**GENOA CHARTER TOWNSHIP
PLANNING COMMISSION PUBLIC HEARING
MONDAY, NOVEMBER 14, 2016
6:30 P.M.
AGENDA**

OPEN PUBLIC HEARING #1...Review of site plan application and impact assessment for an expansion of 34 parking spaces for an existing medical building located at 6888 Grand River Avenue, Brighton. The request is petitioned by Howard Lipkin.

Attention:	Kelly Van Marter, AICP Planning Director and Assistant Township Manager
Subject:	Lipkin Medical Office parking lot expansion – Site Plan Review #1
Location:	6888 Grand River Avenue – south side of Grand River, west of Hubert Road
Zoning:	NSD Neighborhood Services District

**Re: Lipkin Parking Lot
Site Plan Review**

Exhibit 1-c

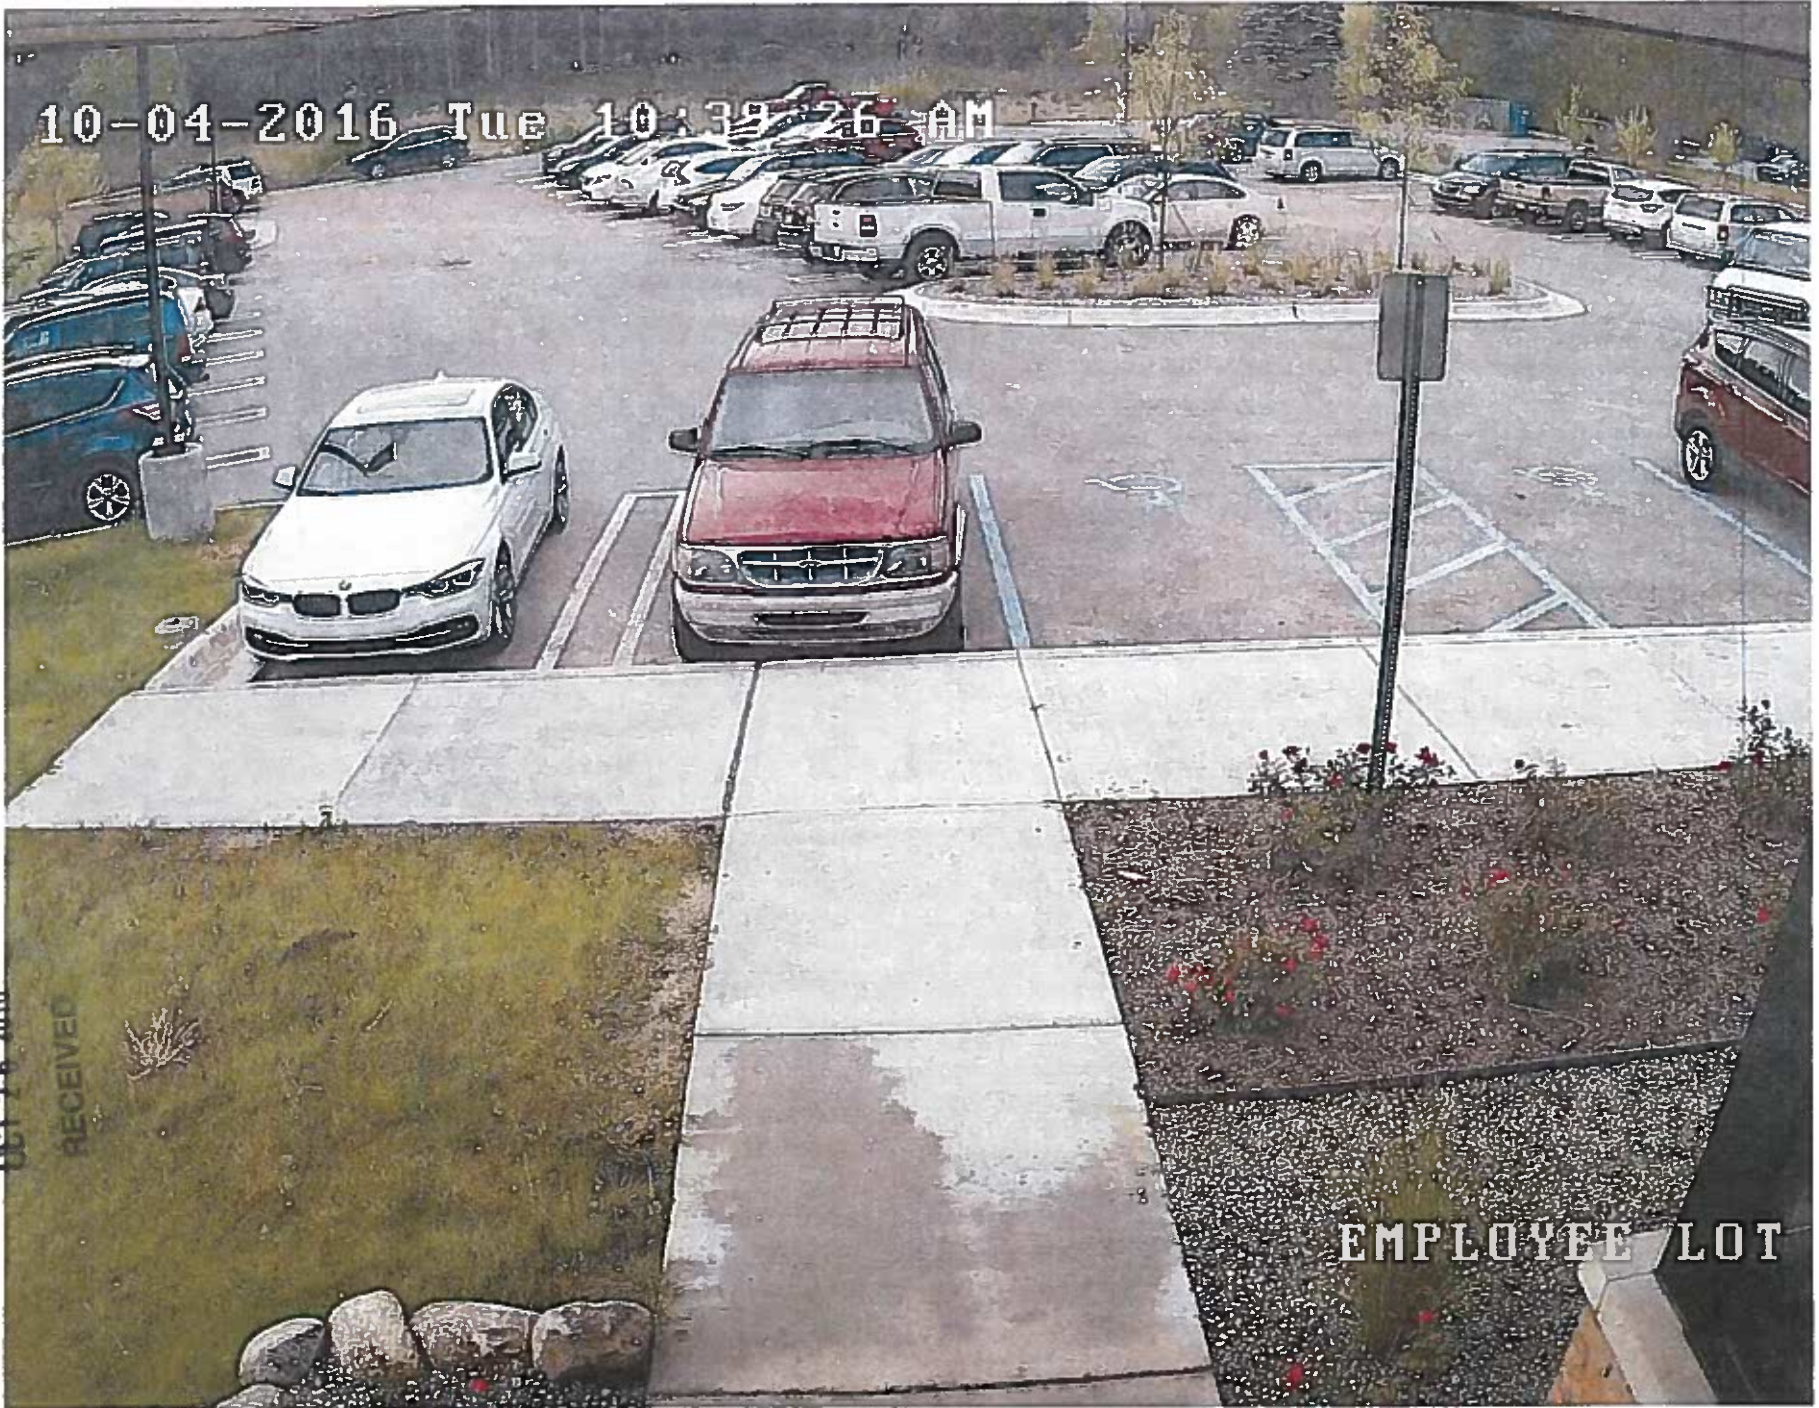
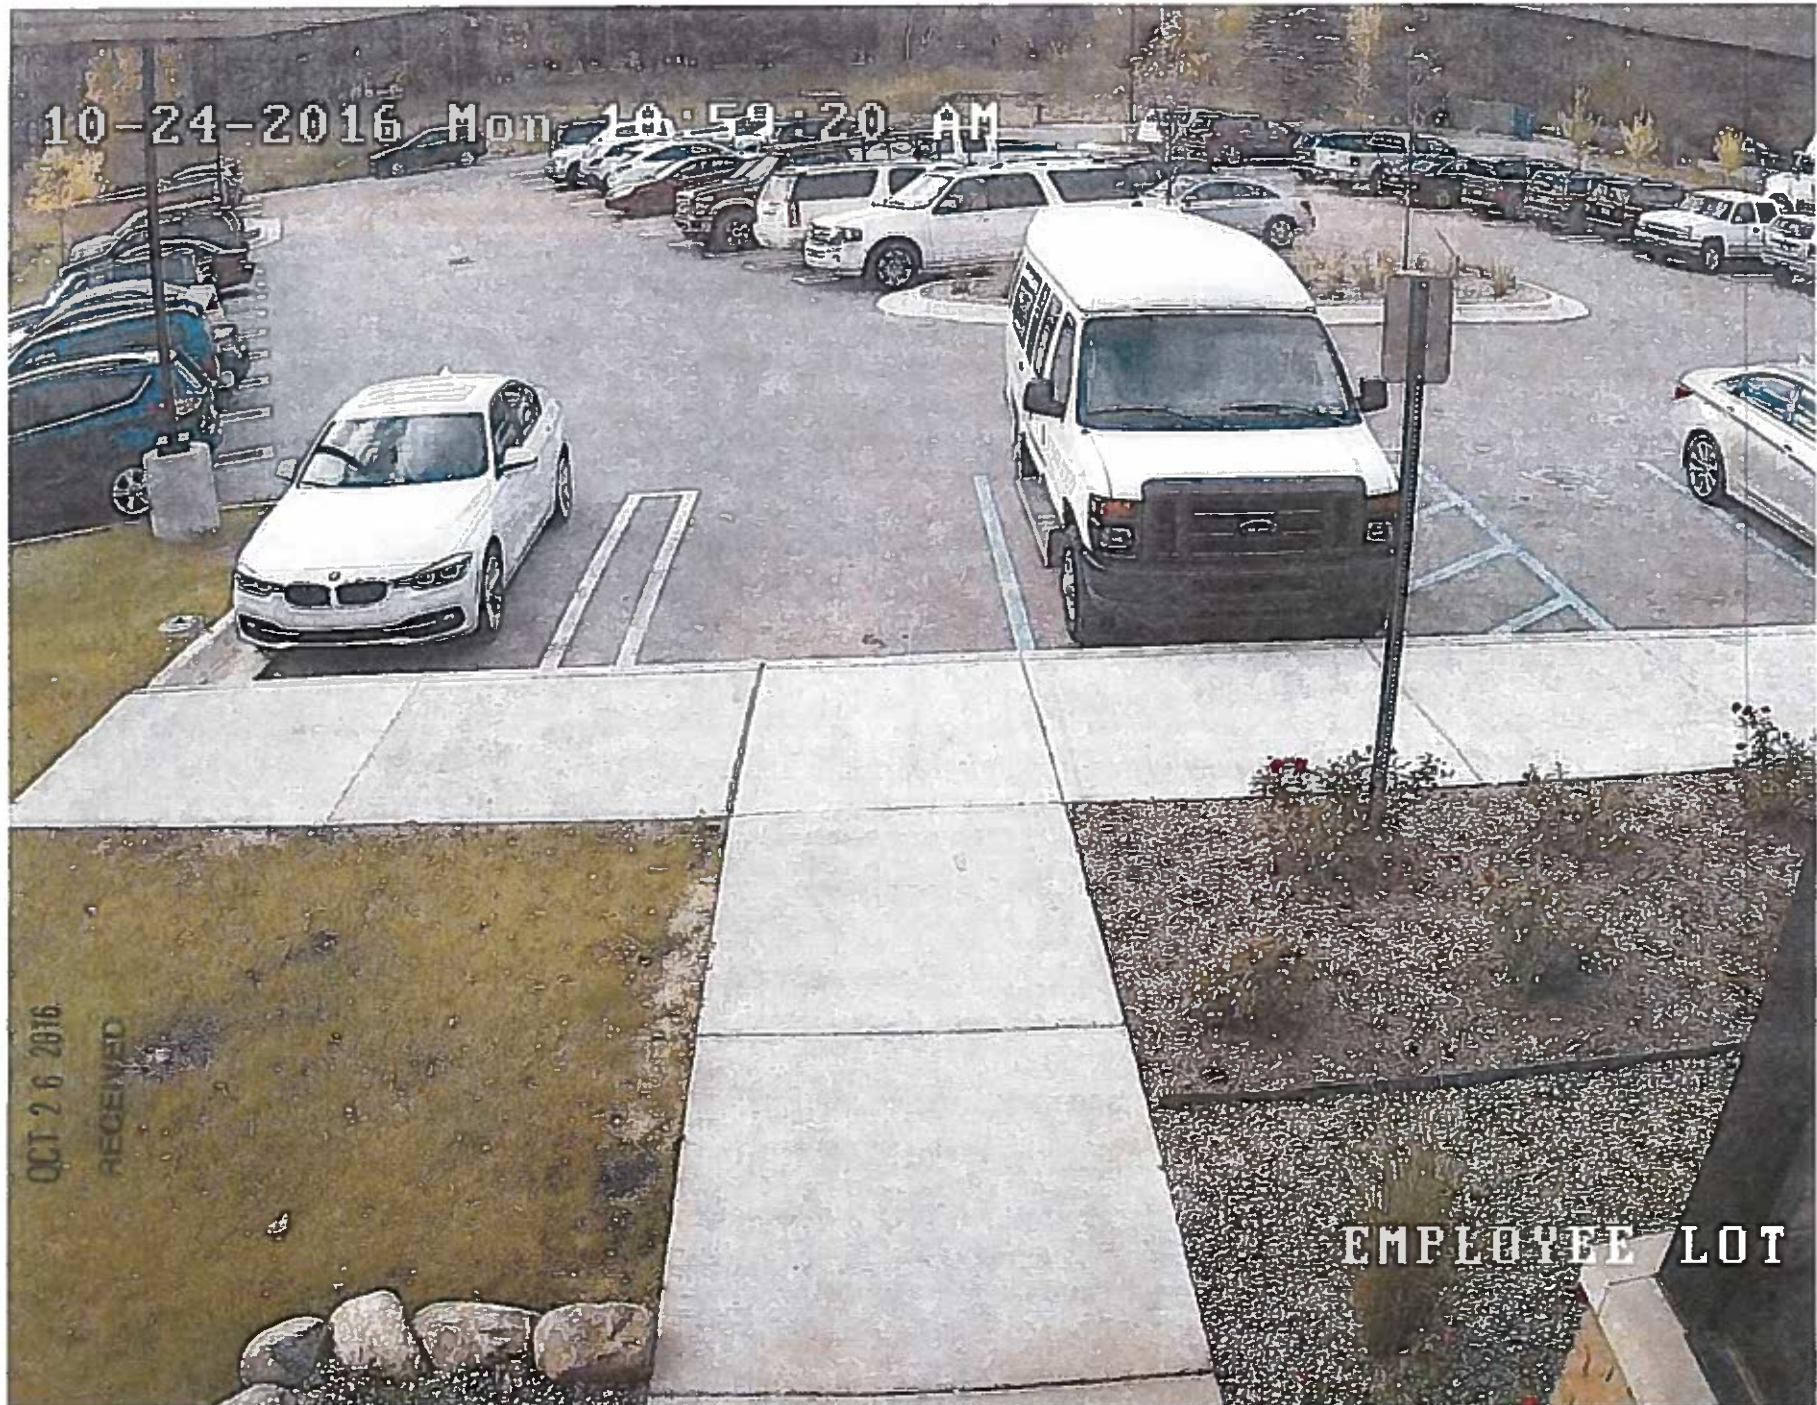
In support of this request, the submittal indicates there are parking shortages during peak business hours, including several photos of a relatively full parking lot. Additionally, the original site plan approval included a parking ratio of 137.5% based on the stated needs of the applicant at that time.

DESIGNED BY: TD
 DRAWN BY: TD
 CHECKED BY: TD
 SCALE: 1" = 30'
 JOB NO.: 13-293
 DATE: 4-30-14
 SHEET NO.: **C2**

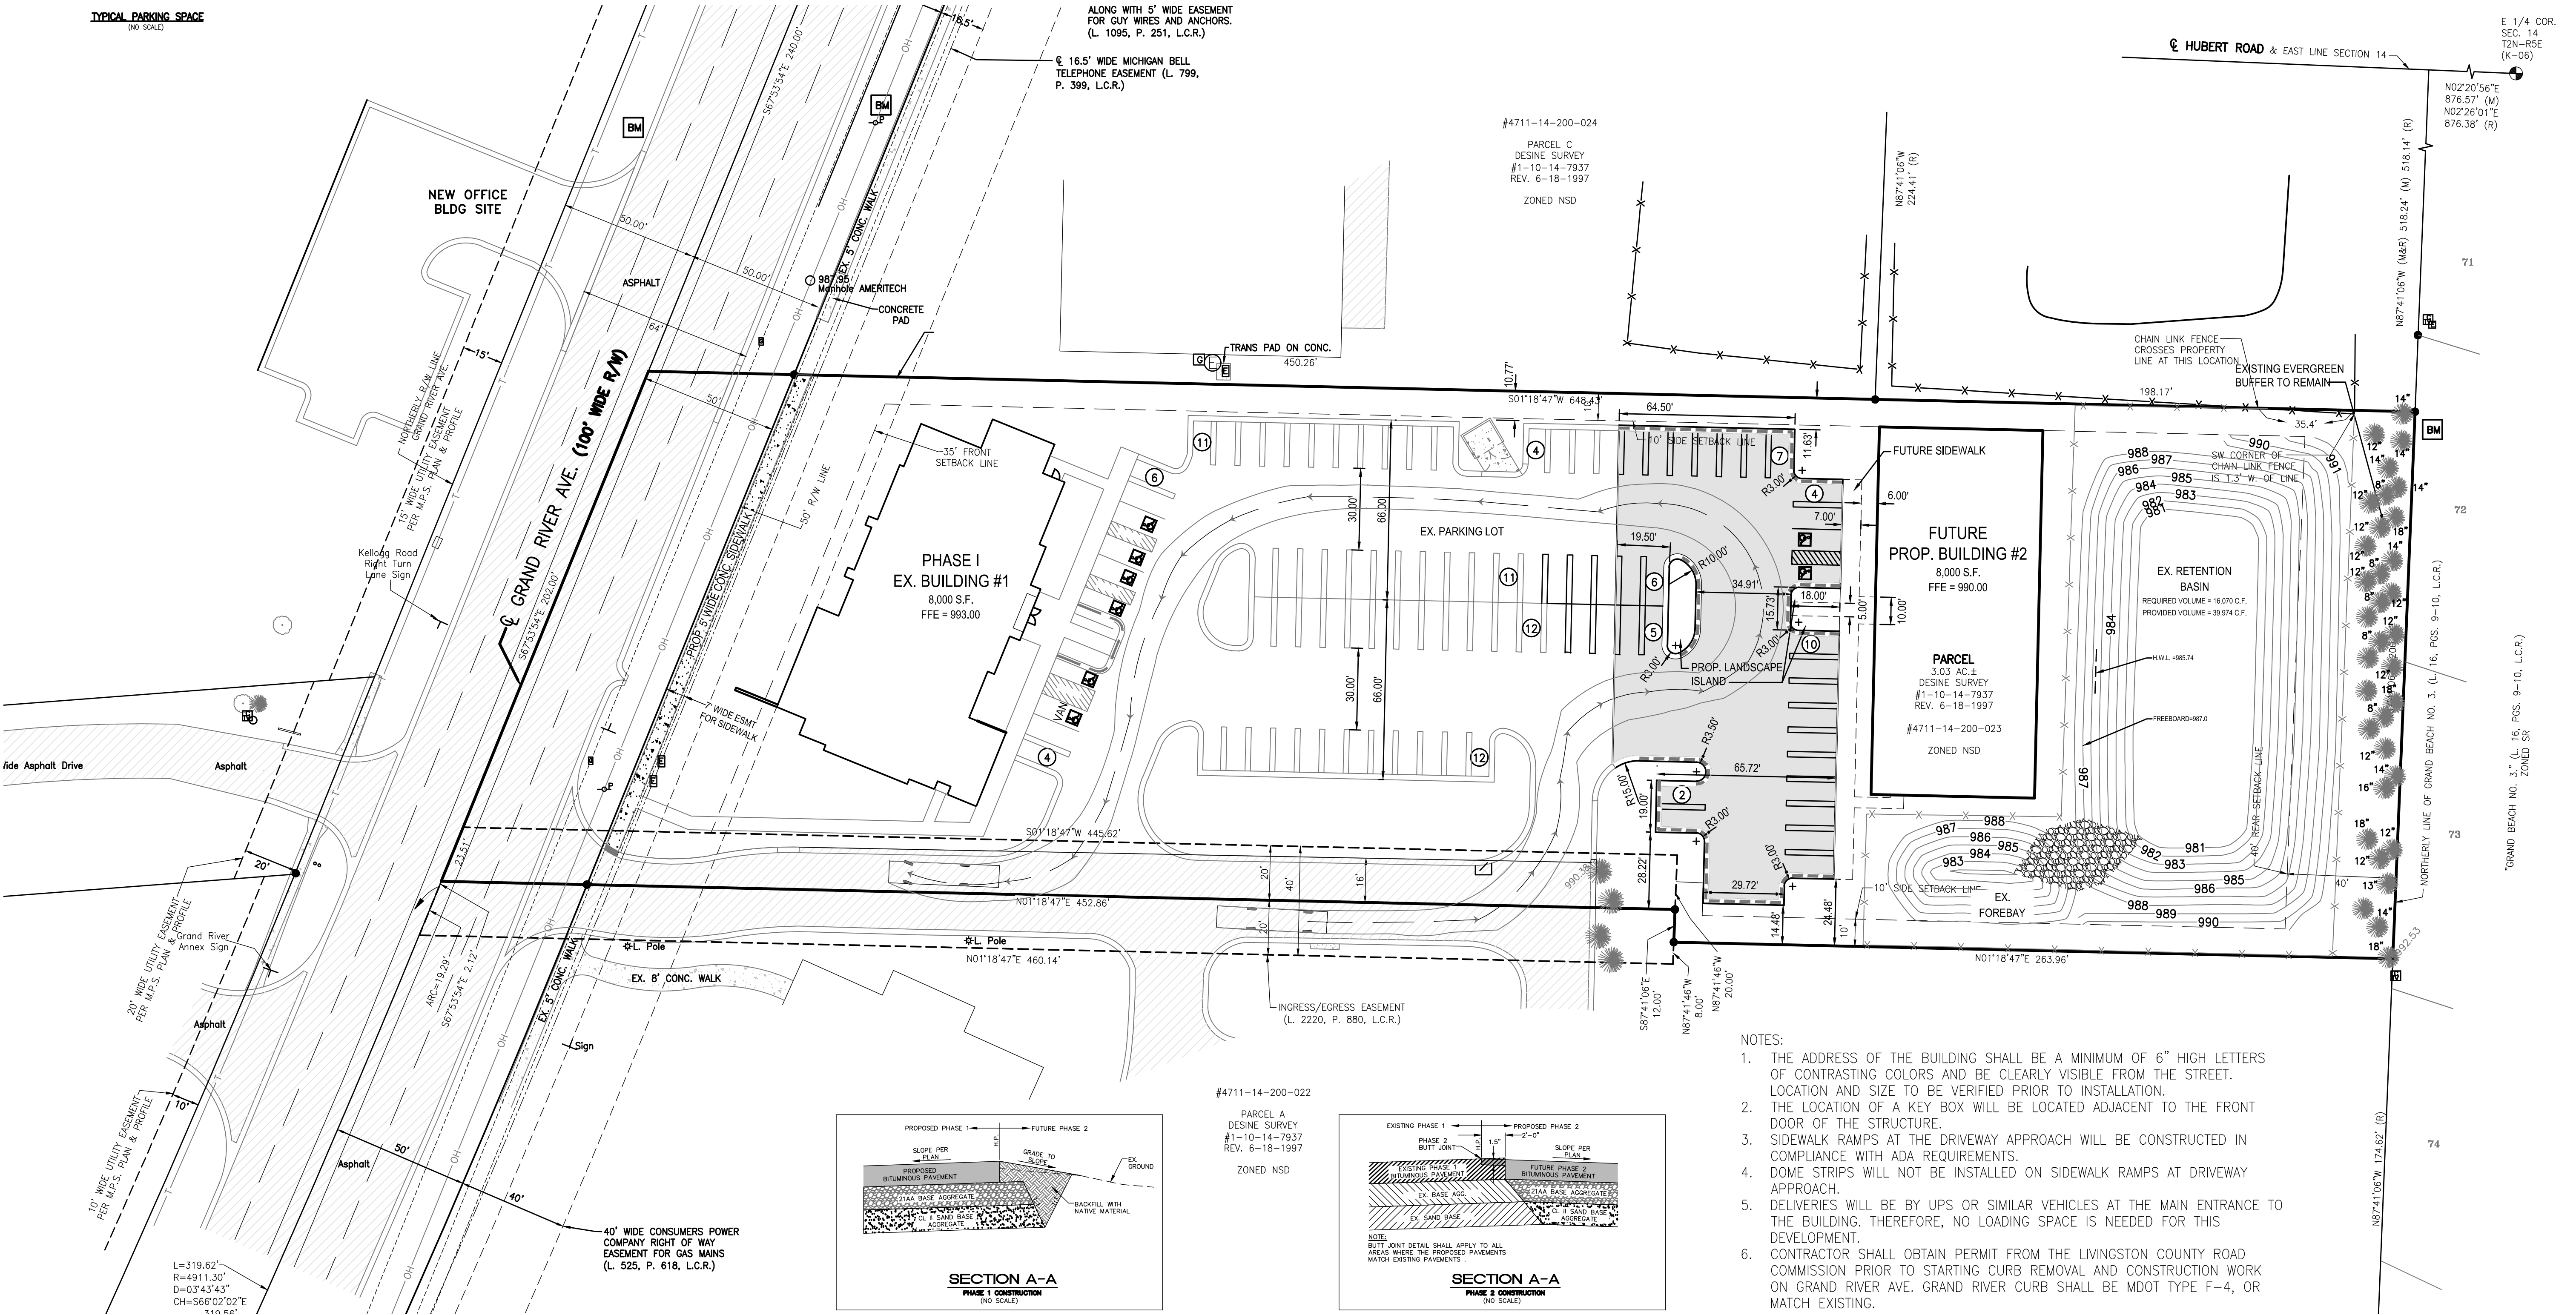
1. Planning Commission approval is needed for the amount of parking proposed (235% of the minimum requirement). The submittal indicates that the additional parking is needed given parking shortages during peak business hours.

2. We suggest that the applicant utilize the southernmost spaces for employees until such time as the Phase II building is constructed.
3. Given the extreme distance from the entrance to the existing building, we question the need for the 2 new barrier free spaces until the Phase II building is constructed.

Section 14.02.06 requires Planning Commission approval for parking in excess of 120% of the minimum requirement. As proposed, the parking ratio will be 235% of the minimum requirement for the existing building. (If the Phase II building is constructed the ratio will be reduced to 117.5%.)

We suggest that the applicant utilize the southernmost spaces for employees until such time as the Phase II building is constructed. These spaces are approximately 275 feet from the nearest entrance of the Phase I building, which is relatively inconvenient for patrons. Given this distance, we also question the need for the 2 new barrier free spaces until the Phase II building is constructed.

4. **Vehicular Circulation.** No changes are proposed to access to/from Grand River. The drive aisle connections between the existing and proposed parking lot exceed dimensional standards; however, a truck turning template is provided showing the need for the drive aisle widths.
7. **Landscaping.** The greenbelt, detention pond and buffer zone requirements are not impacted by the proposed parking lot expansion. The originally approved landscape plan provided more than sufficient plantings to satisfy these requirements. However, it has come to our attention that the applicant has yet to plant all of the Phase I landscaping. Specifically, the area south of the existing parking lot, including the detention basin, does not include the landscaping required as part of the original site plan approval.
